## CITY OF GARDEN CITY

**File Number: CUPFY2024 - 0004**  
**Requested Use: Cat and dog boarding, dog daycare**  
**Use as Defined By GCC Title 8: Animal Care Facility**  
**Location: 4048 W. Chinden Blvd.**  
**Applicant: Jenny Strozykowski with Hounds Town Boise**  
**Planning and Zoning Commission Hearing Date: February 21, 2024 6:30 p.m.**

### STAFF REPORT

Figure 1: HVAC units and Trash Receptacle

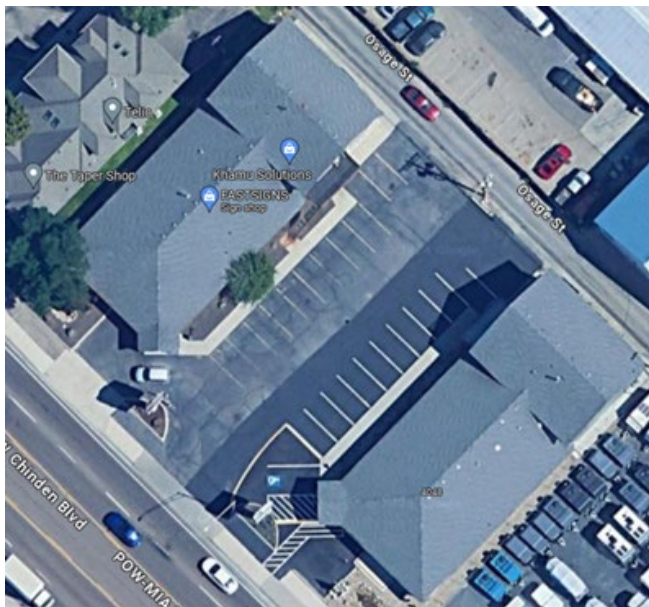
According to Garden City Code Section 8-4A-5, all on-site services such as HVAC and trash enclosures shall not be visible from the right-of-way or adjacent property or shall be screened by a privacy fence. However, the existing configuration of the building, Osage right-of-way, and overhead utilities may not allow for the installation of a privacy fence or screening.

It may be difficult to meet the Republic Services standards for trash enclosures. The standards specify a 12" x 18" (to fit both trash and recycling) with gates opening at least 120 degrees and the gates need to be stacked. If the applicant installs a trash enclosure in accordance with the above requirements, then the trash enclosure at its current location will encroach the Osage right-of-way, which will be prohibited by ACHD. The applicant may try to relocate the trash enclosure to meet code compliance.

Screening of the HVAC units may also be difficult to achieve given their proximity to the Osage right-of-way and the unit's own clearance requirements. Conditions have been drafted to ensure code compliance is met. The Commission may find that the existing site is not undergoing a substantial alteration, therefore waiving the requirements to screen both the trash enclosure and the HVAC units.
